2 November, 2021

We are writing to address the feedback provided after the submission of the report titled "*New Primary School in Mulgoa Rise, Review of Environmental Factors – Noise & Vibration Assessment Report*" (version 2.0, dated 12 August 2021, referred herein as the *REF N&V Report*).

New Primary School in Mulgoa Rise

Review of Environmental Factors – Noise & Vibration Assessment Report

Logger Location 3: No. 21 Darug Avenue, Glenmore Park

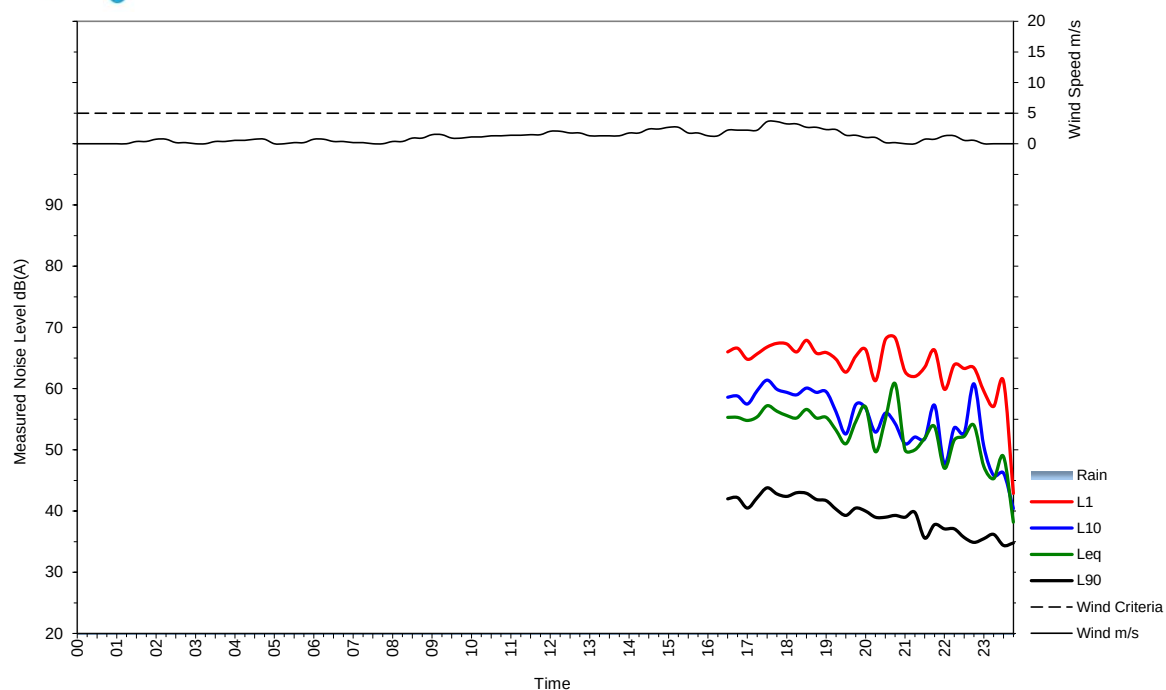
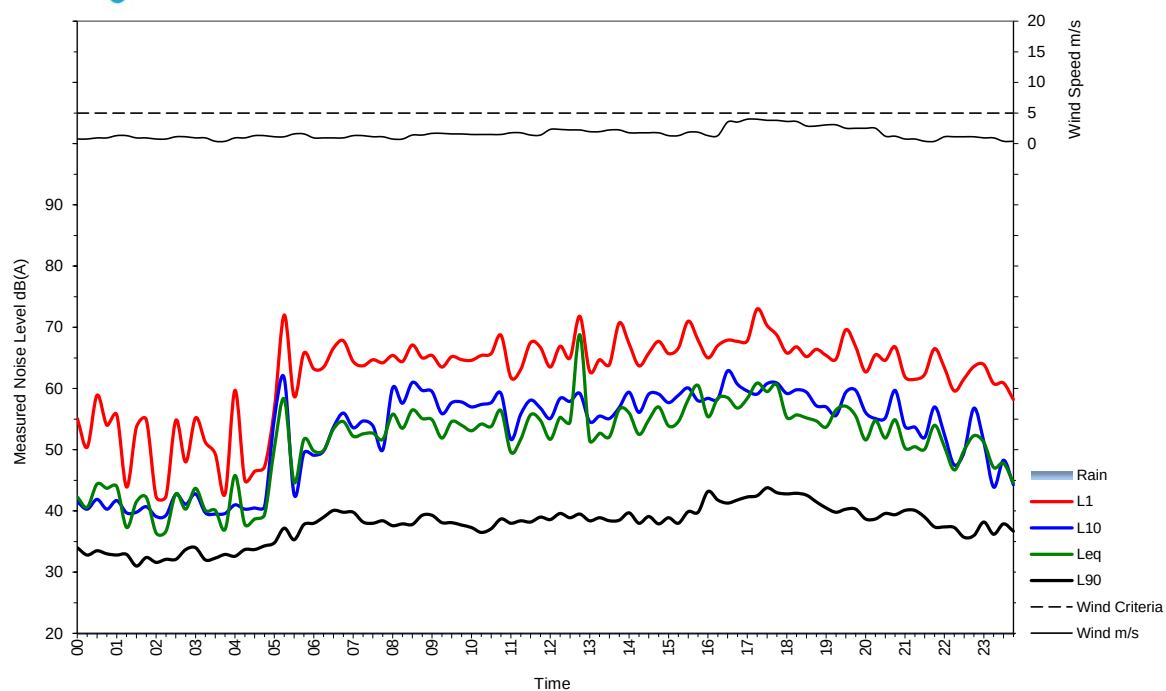
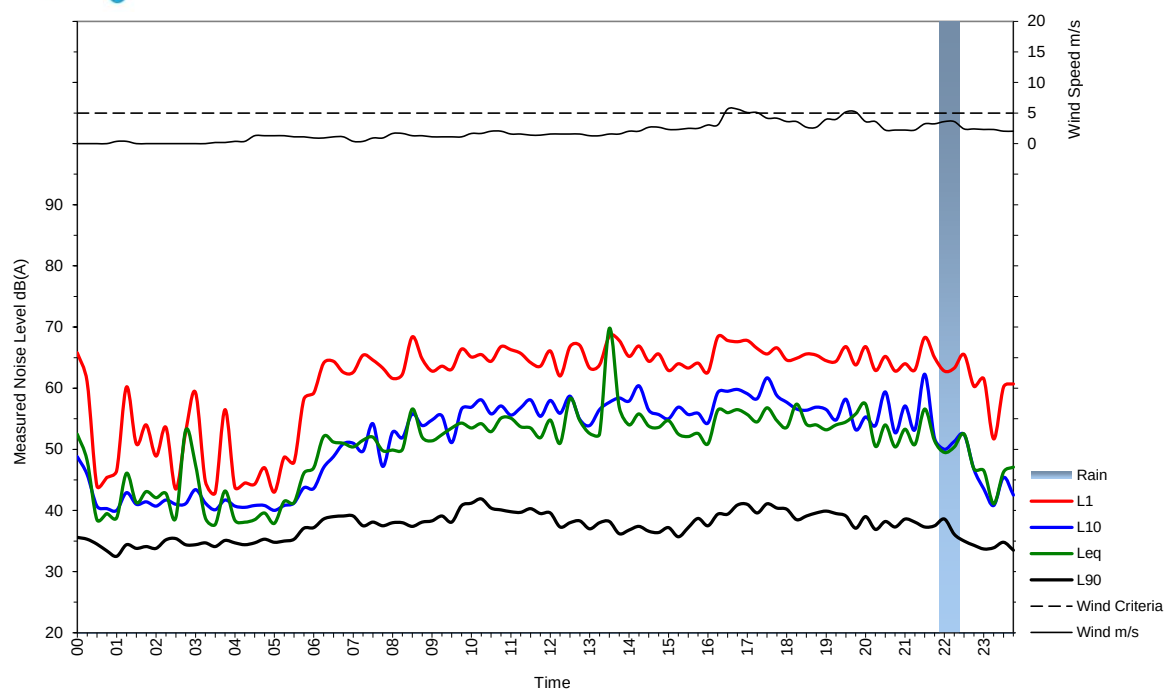
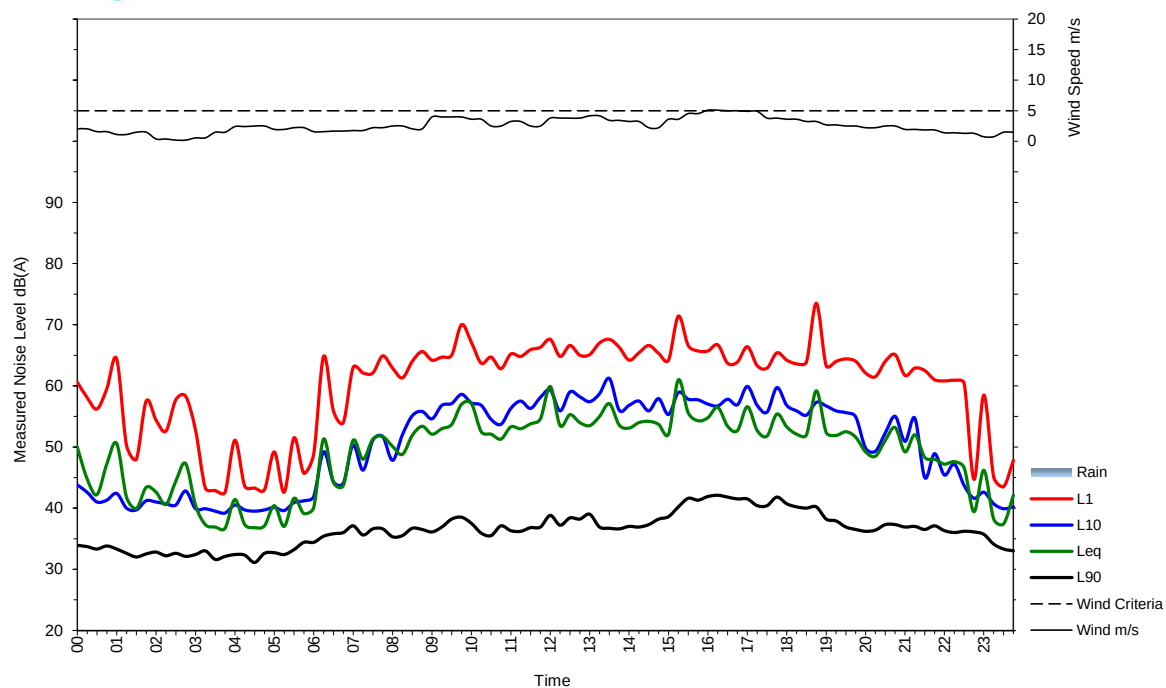
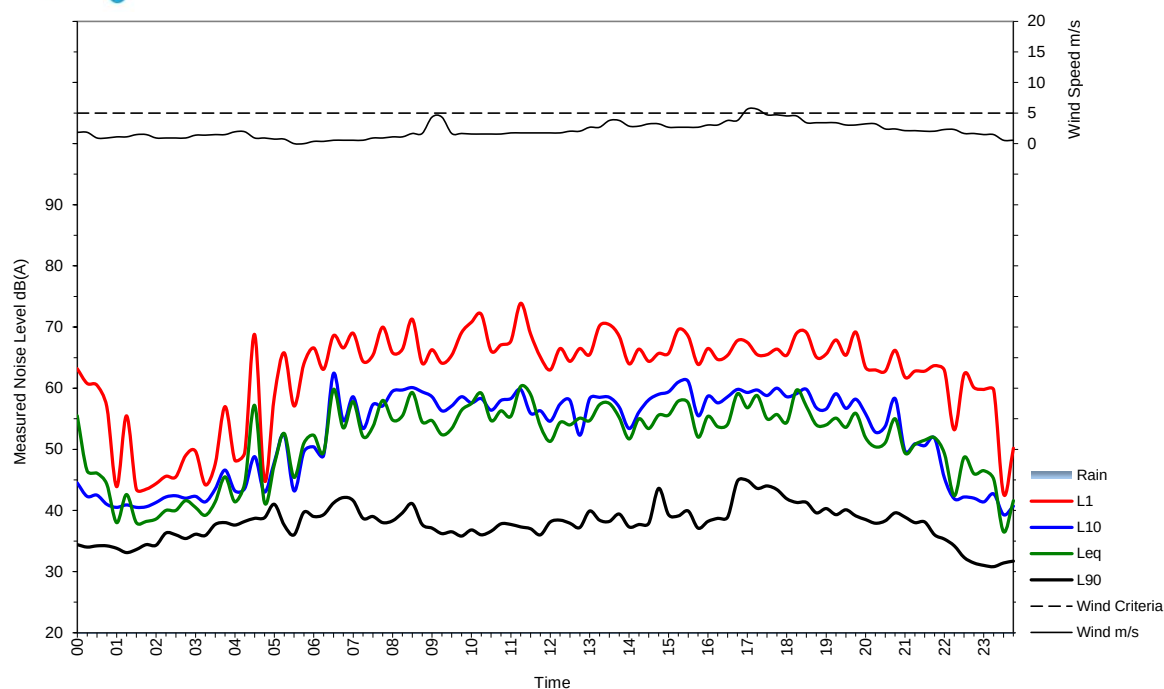
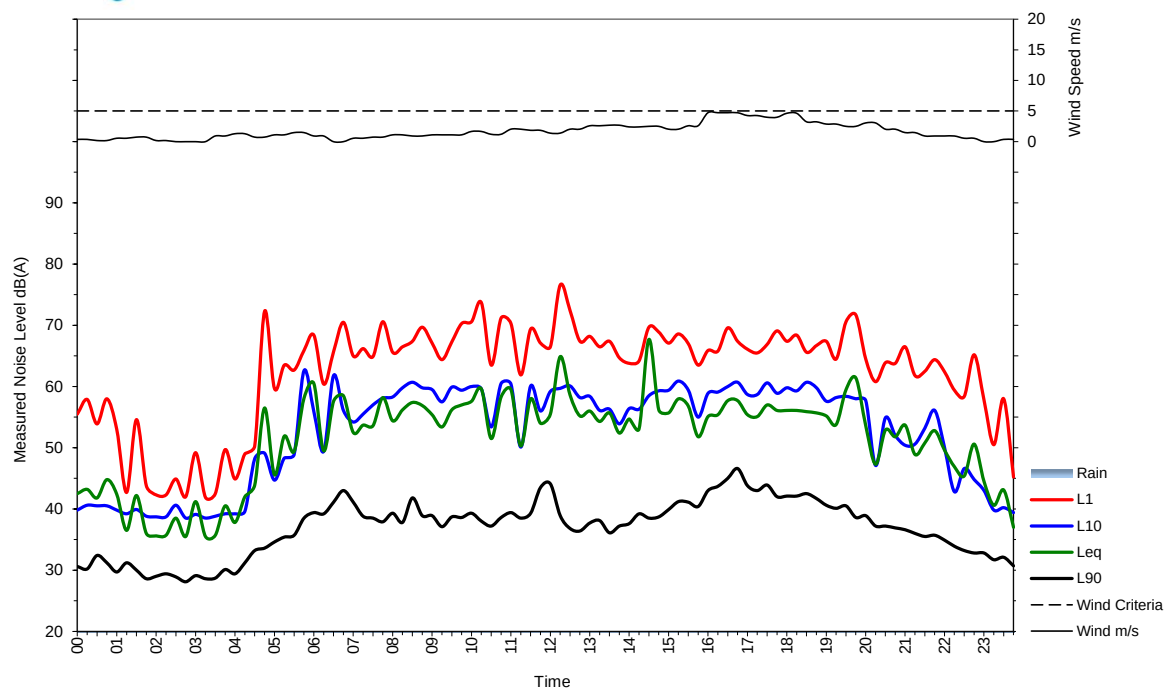
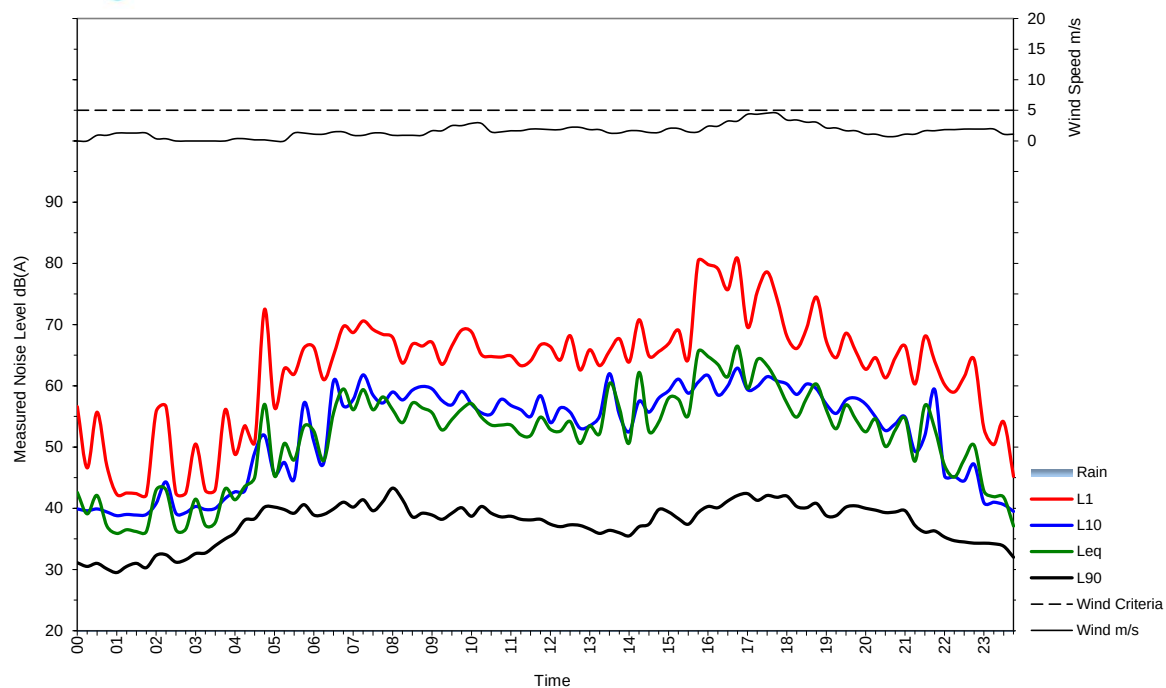
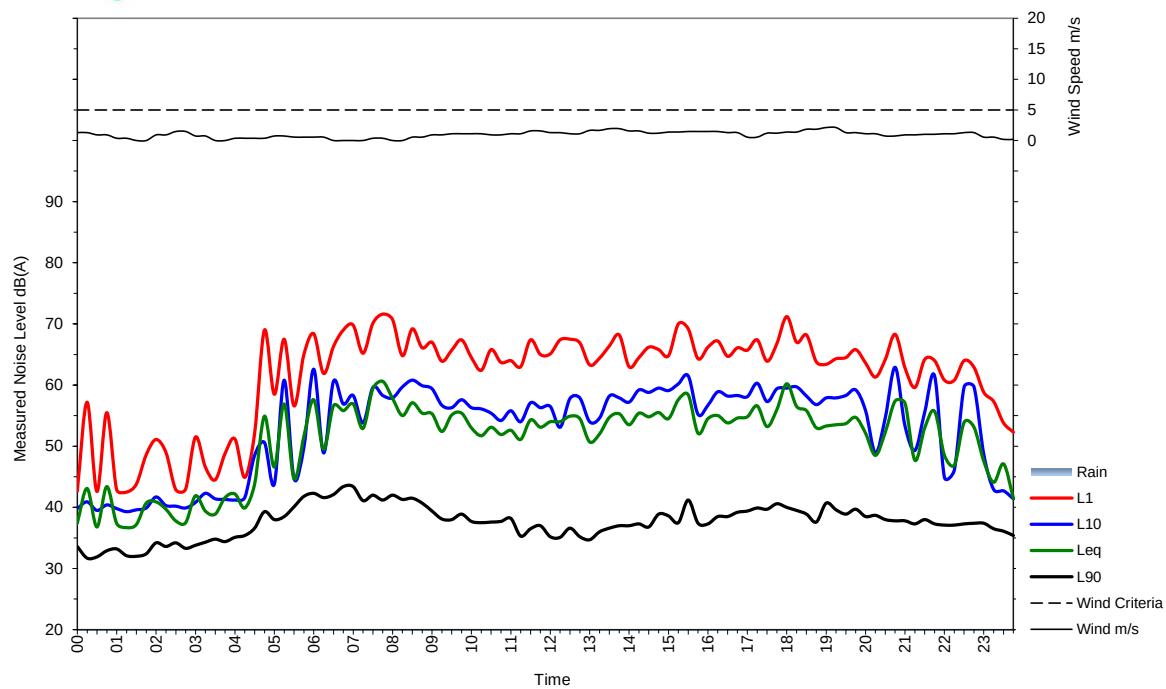
School Infrastructure NSW (SI NSW) has requested that additional unattended noise measurements be undertaken at residential locations along Darug Avenue, facing the project site.

Therefore, these additional noise measurements were conducted at residence located at 21 Darug Avenue, between 21 October and 29 October 2021. As a result, the acoustic assessment has also been updated to account for these additional measurements.

The findings from these additional measurements are discussed in updated REF N&V Report, this is included in Appendix A of this letter. For measurement results corresponding to this additional survey, refer to Section 2 of this report. For updated criteria and assessment, refer to Sections 3, 4, 5 and 6.
